**APPENDIX 4B**

**DETAILED DRAWINGS FOR THE 200 AREA EFFLUENT TREATMENT FACILITY  
CONTAINER STORAGE AREA AND TANK SYSTEMS**

1. ECN 647892

H-2-89044, SW 1

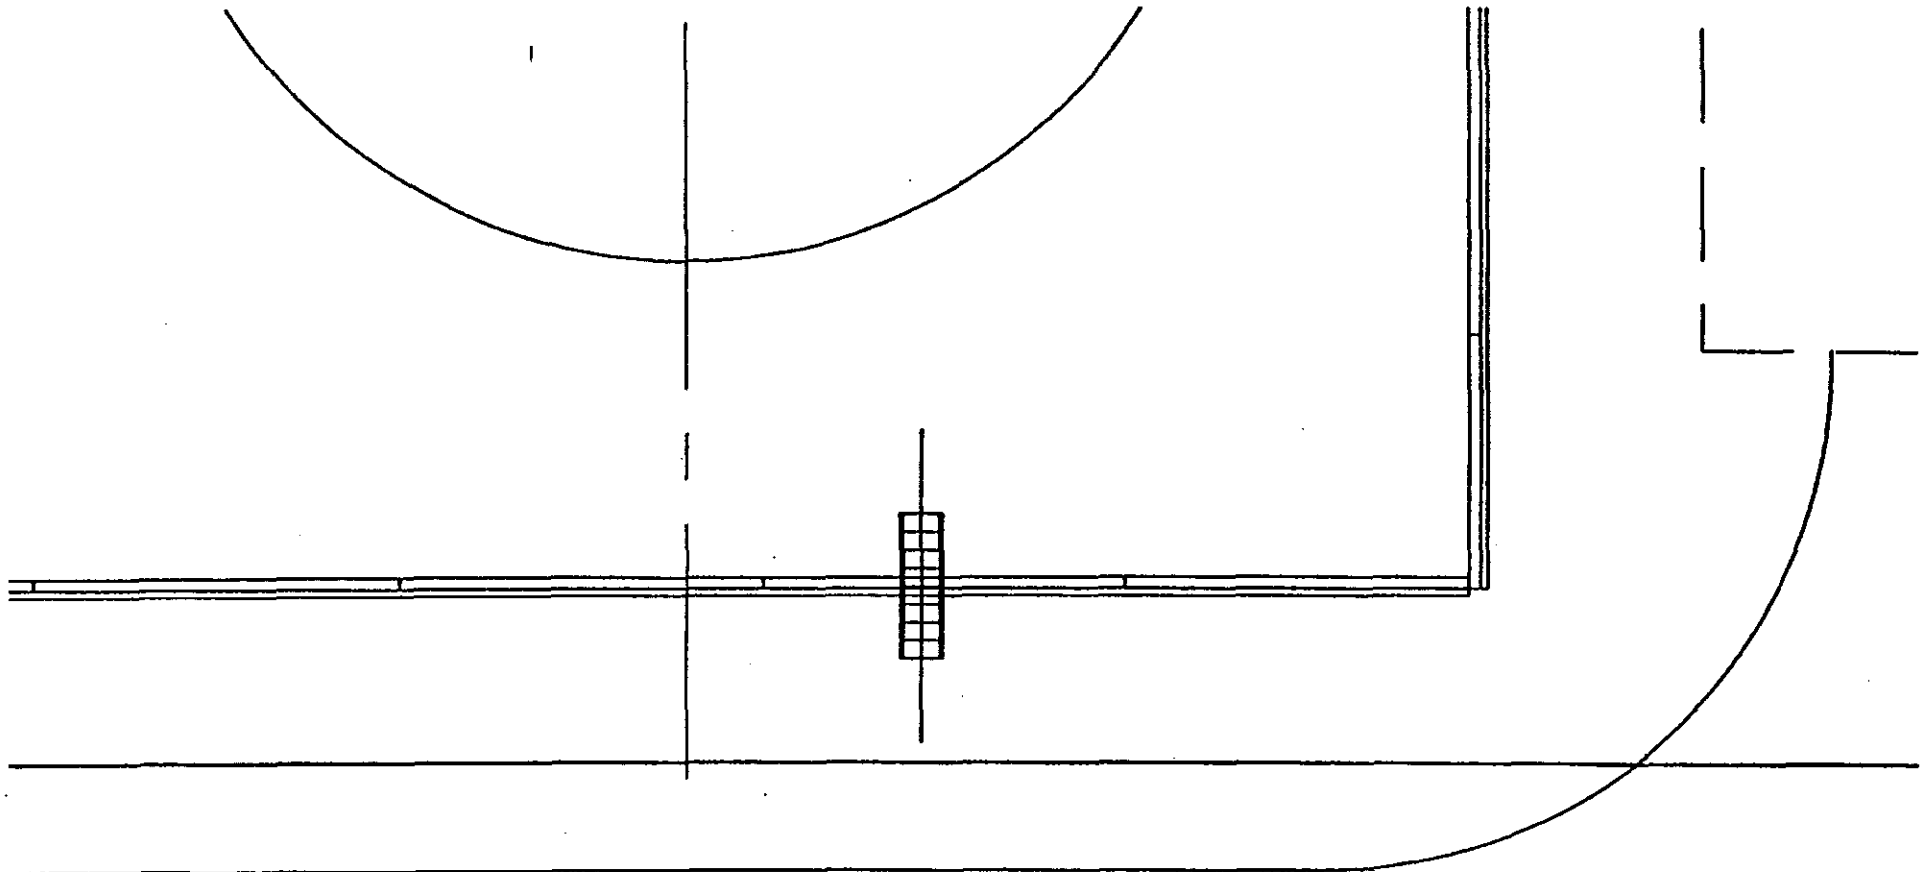
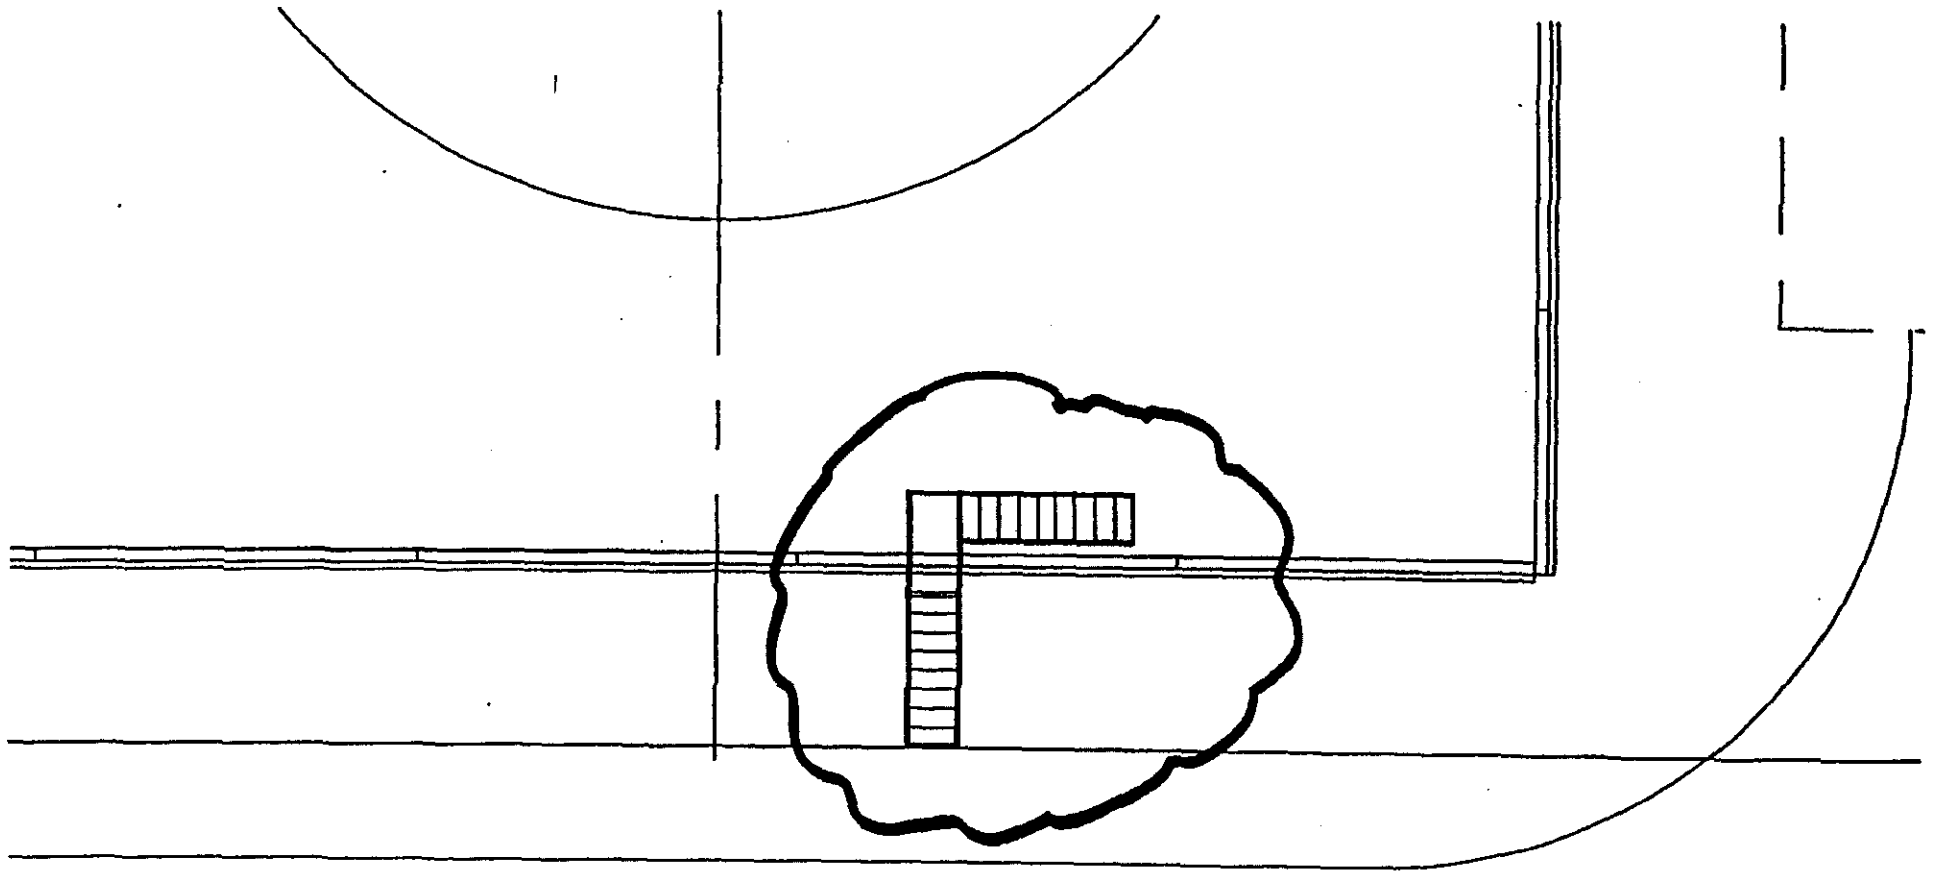
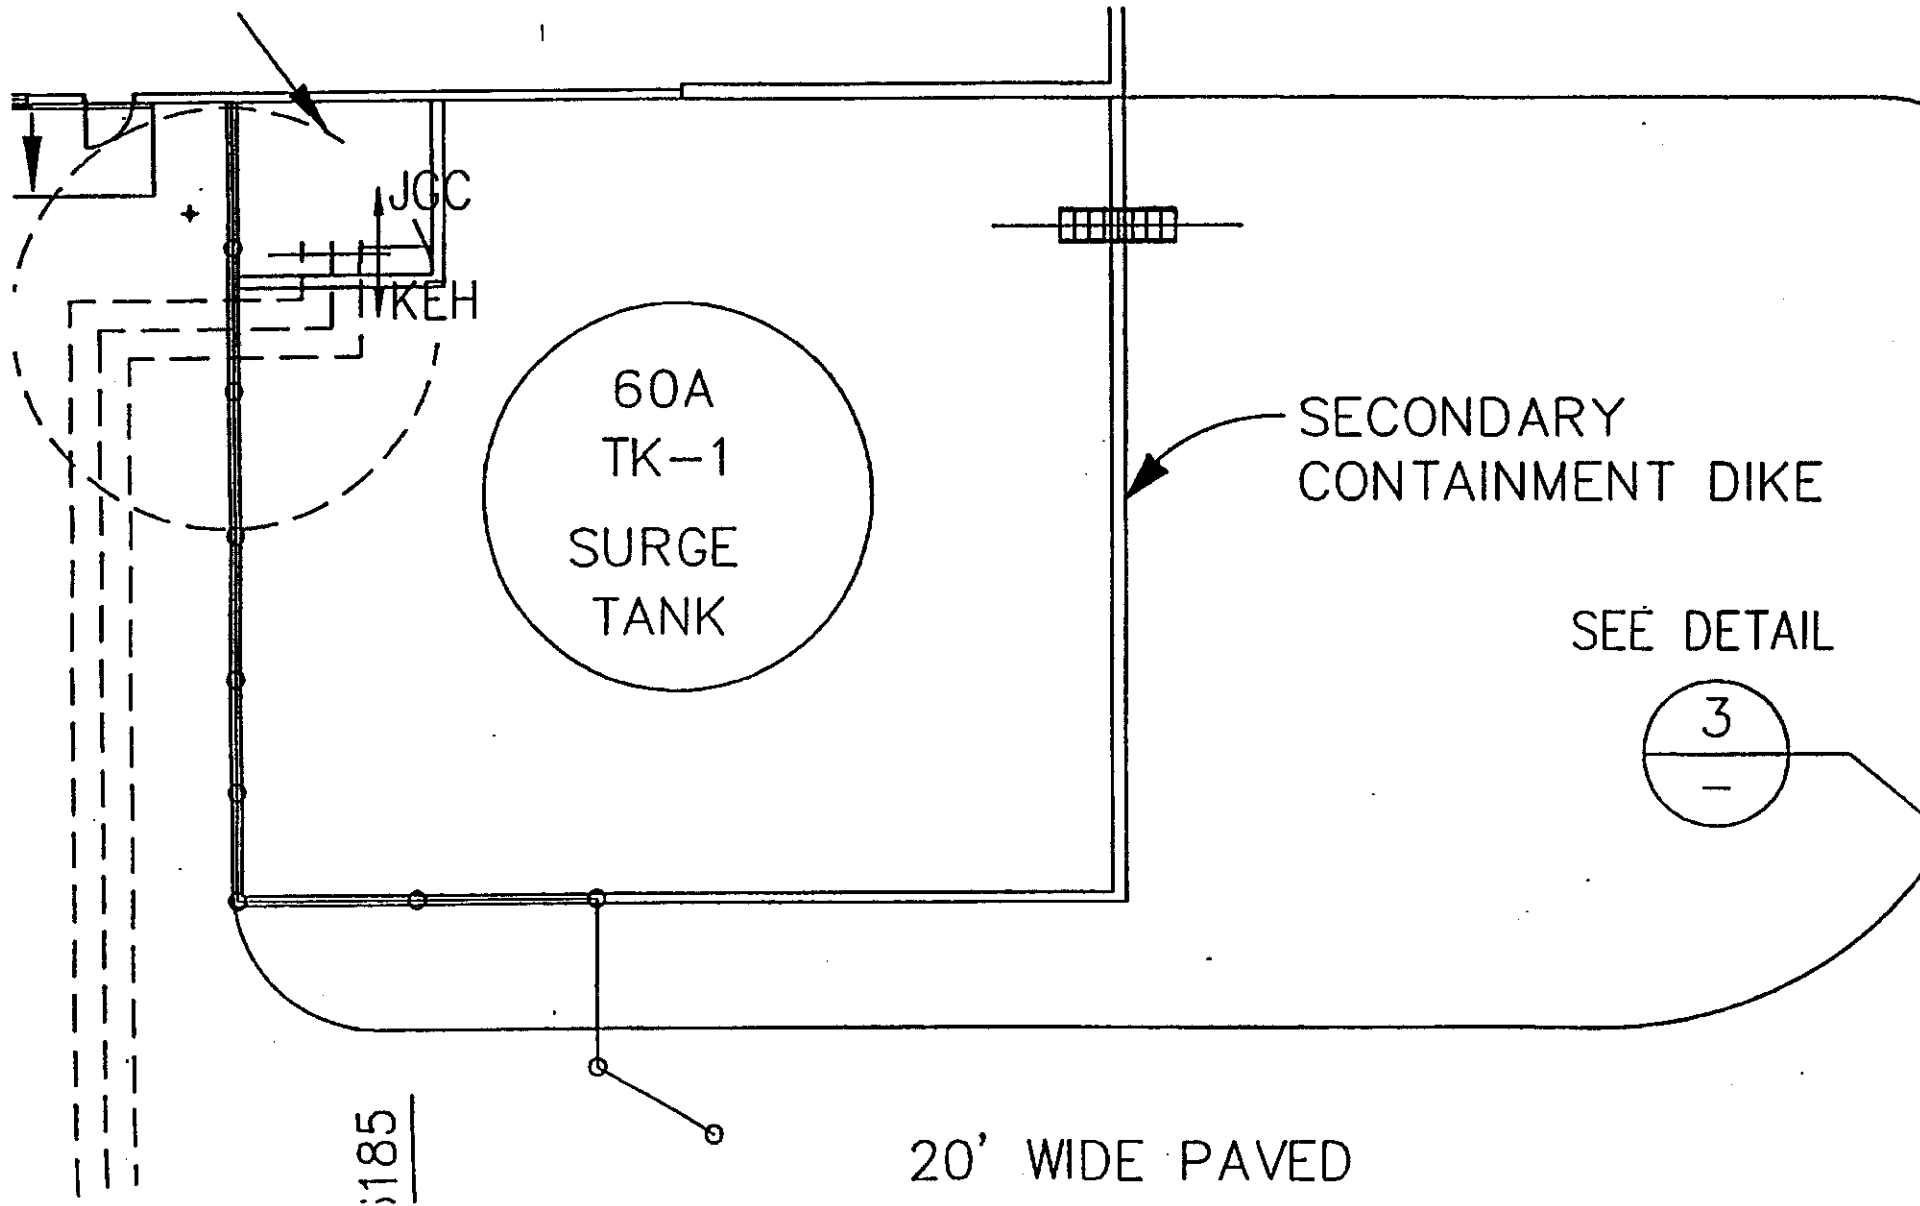
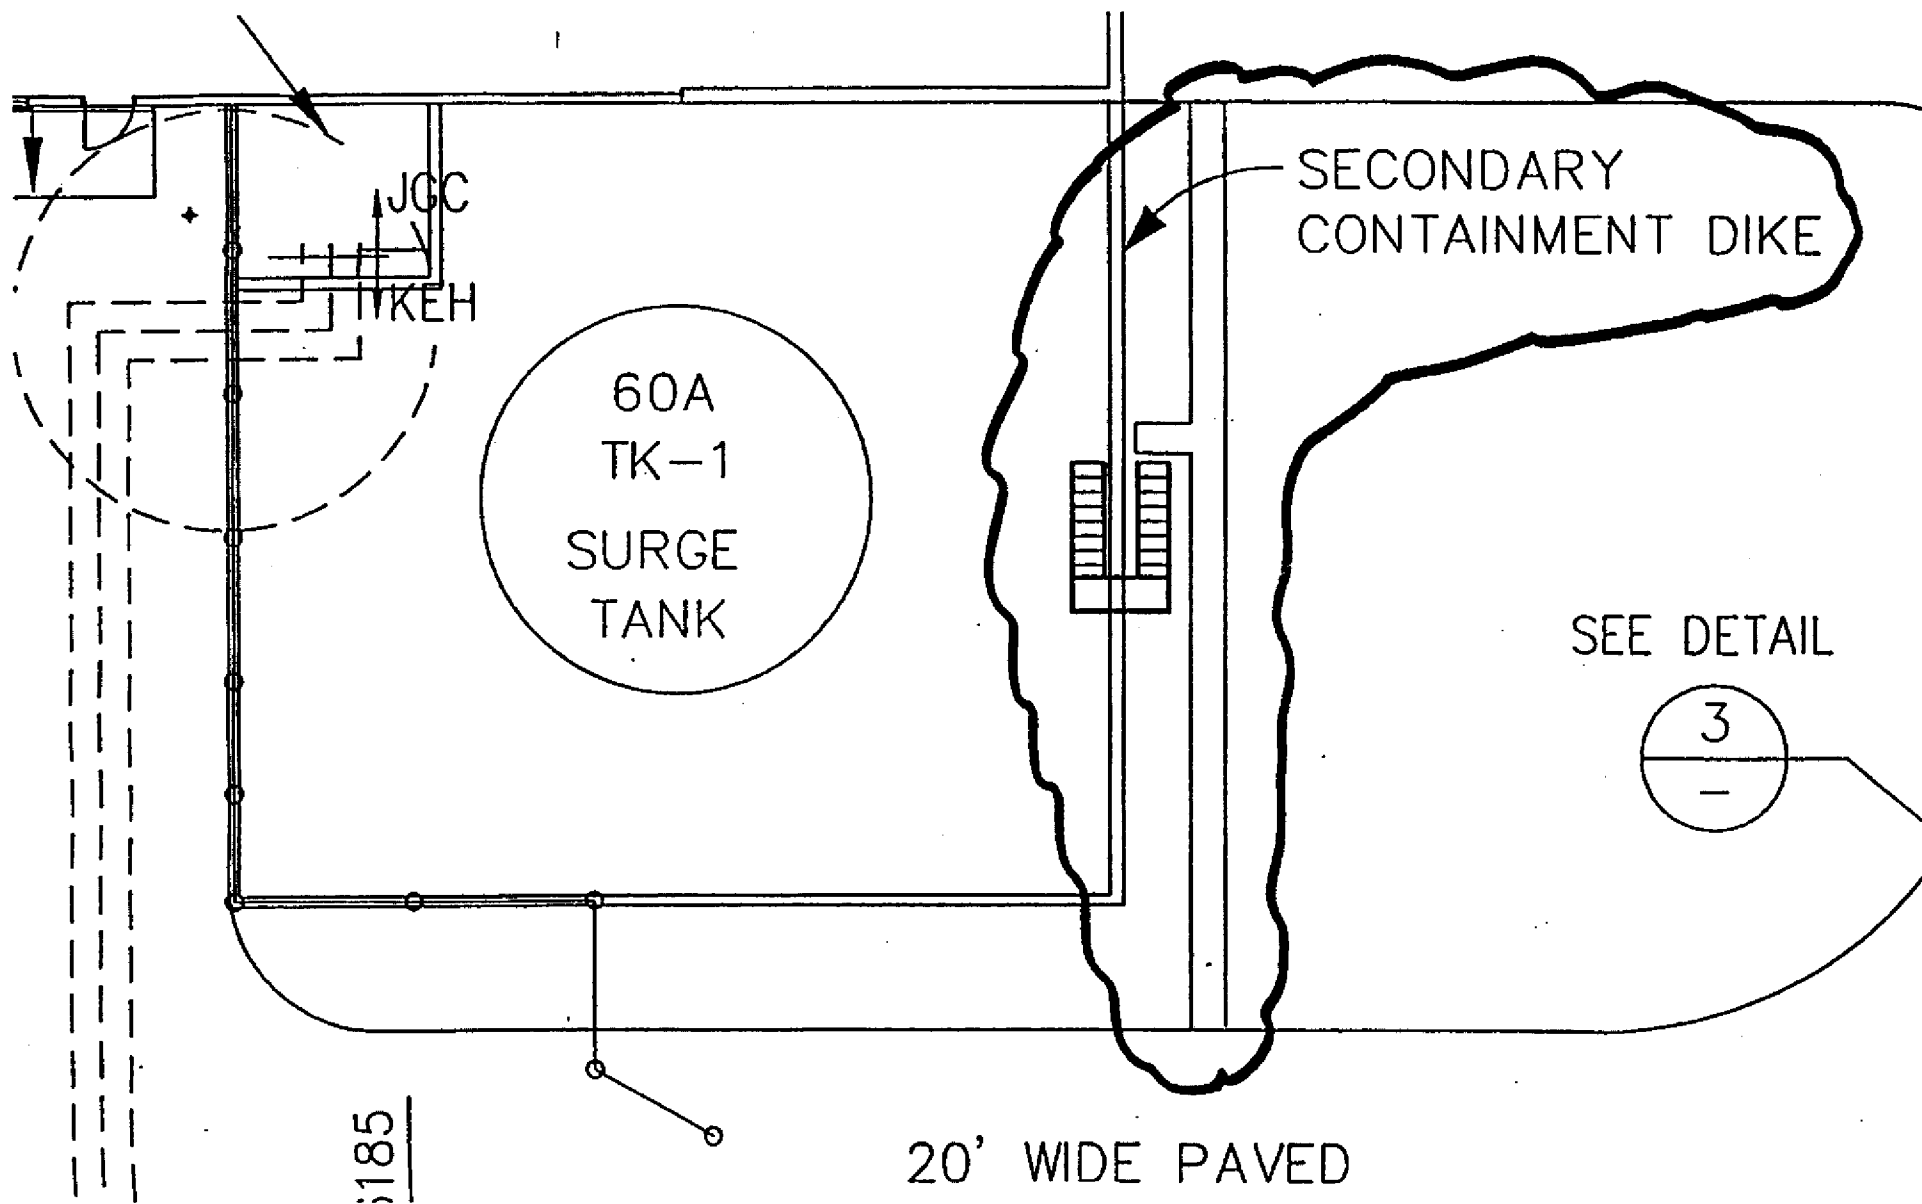
- H-2-89033, Sh 1, Zone D-3: Replace ladder with stairway.
- H-2-89036, Sh 1, Zone E-4: Replace ladder with stairway.
- H-2-89039, Sh 1, Zone B-4: Replace ladder with stairway & show new sidewalk.  
Zone E-4: Replace ladder with stairway.
